Index 646-001

Aluminum Post and Pedestal Mounted Pedestrian Detectors and Signals

COMMENTARY

COMMENTS AND RESPONSES

INDEX	SHEET
646-001	1 of 1

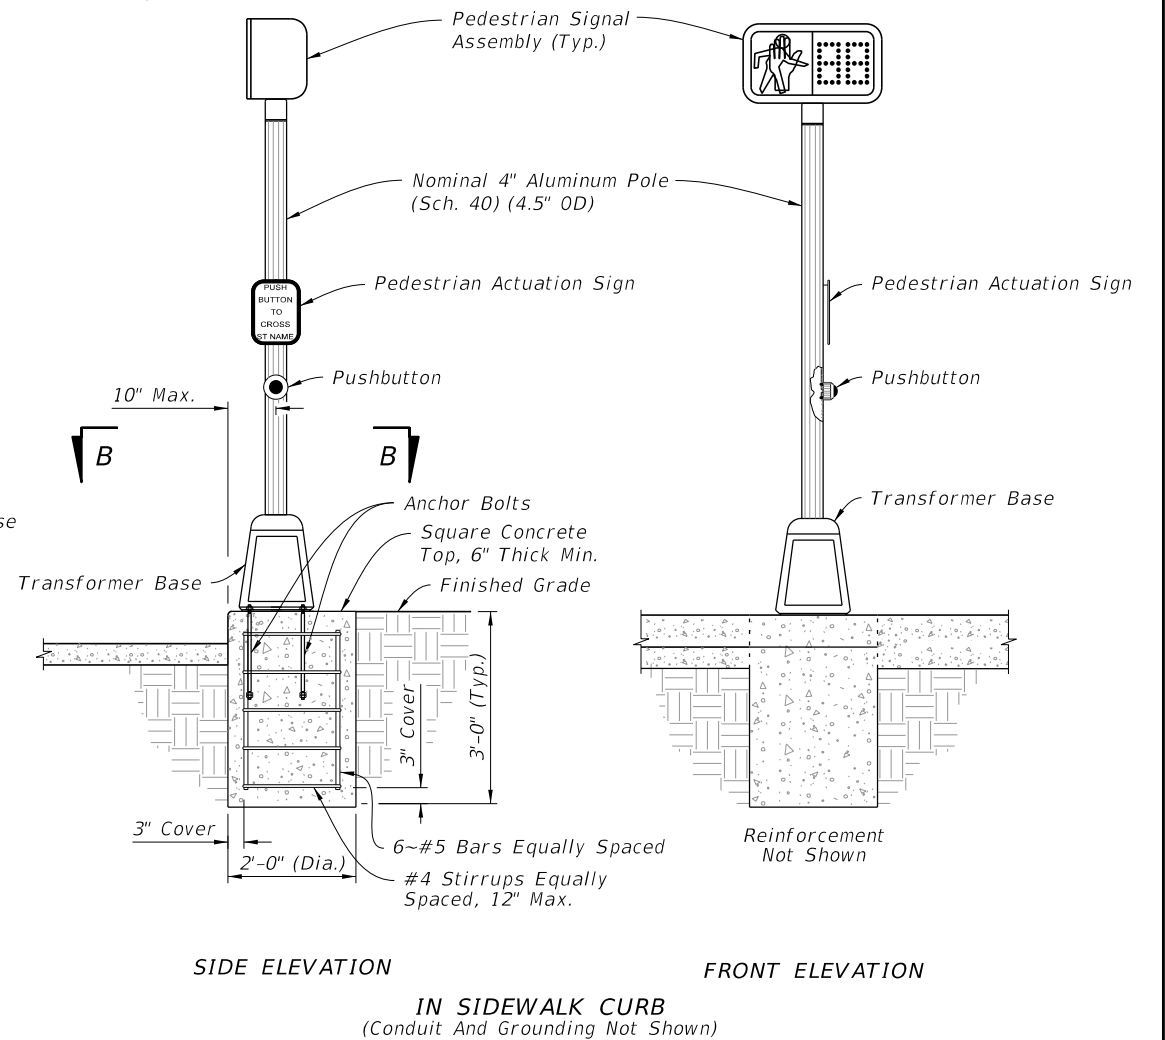
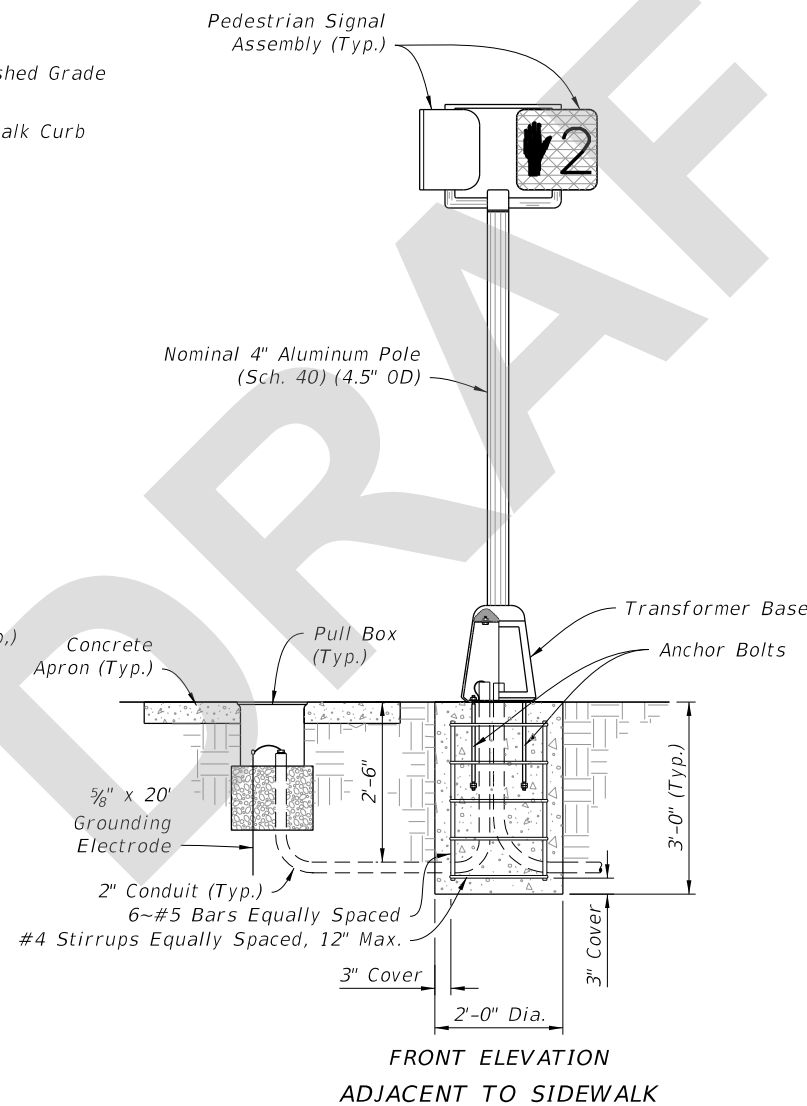
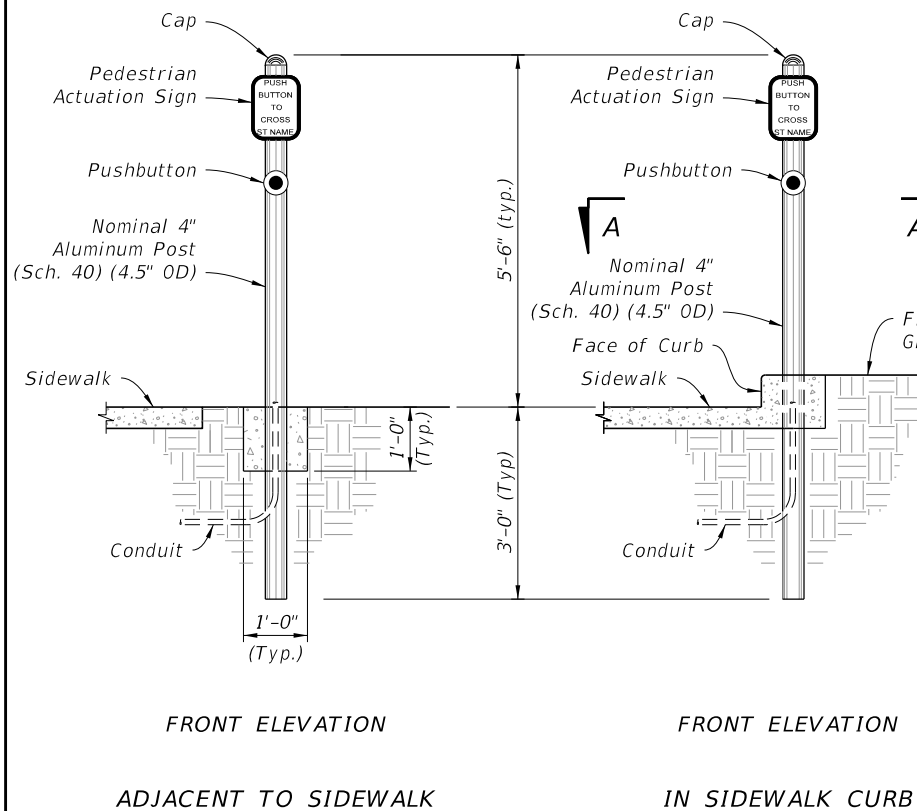
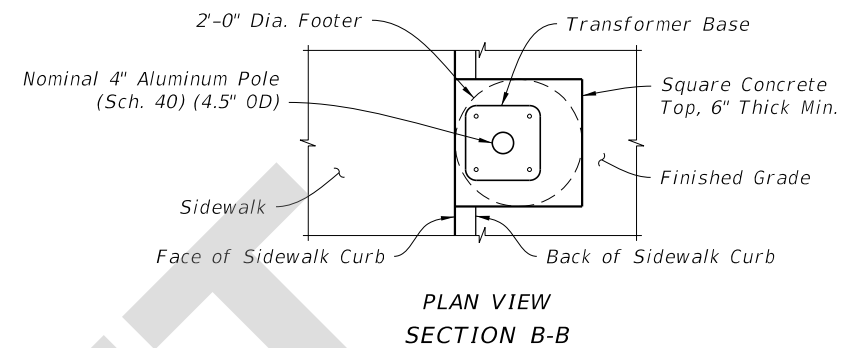
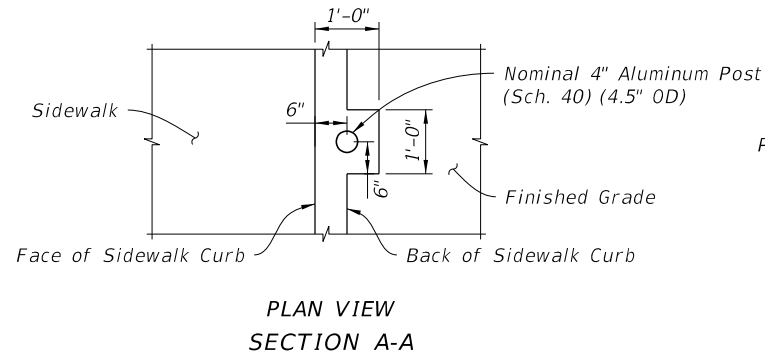
COMMENT: Has the revision of pole diameter callouts from 4" nominal to 4.5" OD been properly coordinated? This change could incur cost updates and other design considerations and affect APL. Were structural parameters considered? Specification 646 references 4" nominal which needs to be updated.

RESPONSE: The pole/posts are not changing with this update so there are no issues with the APL or additional costs incurred. This change was requested by the Structures Office to make callouts consistent with other Indexes that specify pole/post dimensions. The 4" nominal and 4.5" OD are the same callout in this scenario based on ASTM B429 which is a requirement of Spec 646. Although there is no conflict, Spec 646 will be updated to be consistent with the new callout in Indexes 646-001, 654-001, 695-001, and 700-120. The callout in the indexes will be updated to clarify that the poles/posts are not changing.

Change Made: Revise callouts in the Indexes and Spec to read "Nominal 4" Aluminum Pole (Sch. 40) (4.5" OD)"
